City of Raleigh

Title: Wake BRT New Bern Avenue Construction Package 1

ADDENDUM NO. 1

RE: WAKE BRT NEW BERN AVE PROJECT ADDENDUM NO. 1

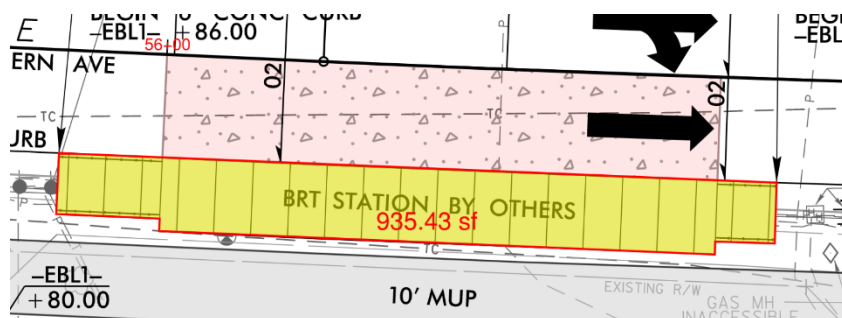
- **Question:** There are items for “Asphalt Pavement Repair Water/Sewer” in both the Utilities and the Utility Betterment sections. However, there is no Asphalt Pavement Repair item for the storm sewer installation. Can an item “Asphalt Pavement Repair Storm” for this be added to the storm sewer section? If not, where does the asphalt removal and the asphalt patching for the storm installation get paid?

Answer: Reference item NBA 0054 within the bid schedule, which includes quantities estimated for pavement repair related to storm installation.

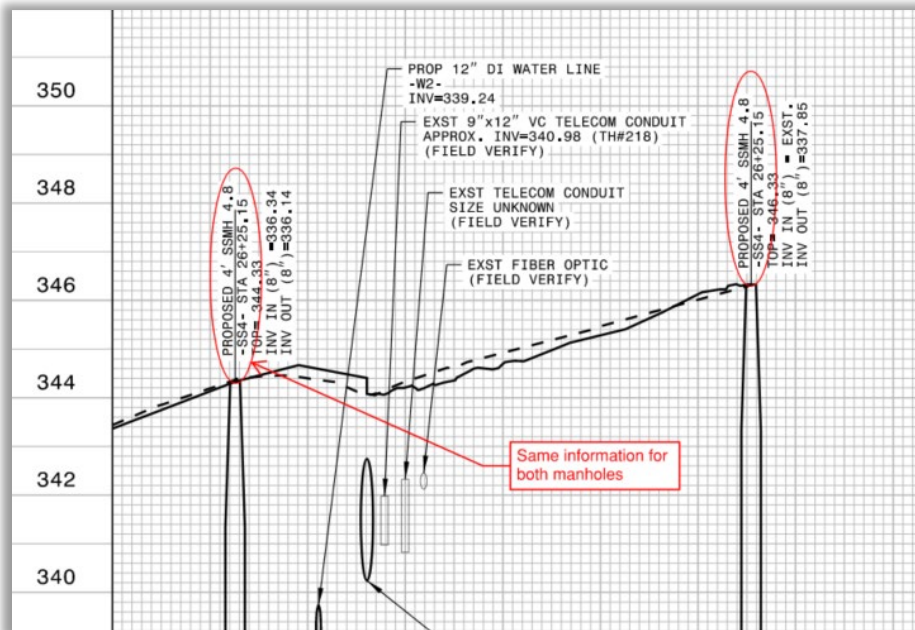
- **Question:** Other than coordinating with the vertical station contractor, what is the Package 1 contractor responsible for, if anything, in the bus stop areas, depicted in yellow below?

Answer: Construction Package 1 contractor is responsible for coordination with the City of Raleigh and Vertical Station Contractor for the station construction area highlighted in yellow, including maintaining construction access. In addition to this area, conduit and fiber installed with construction package 1 will stub up at the cabinet locations adjacent to station platforms as indicated in the plans and will require coordination.
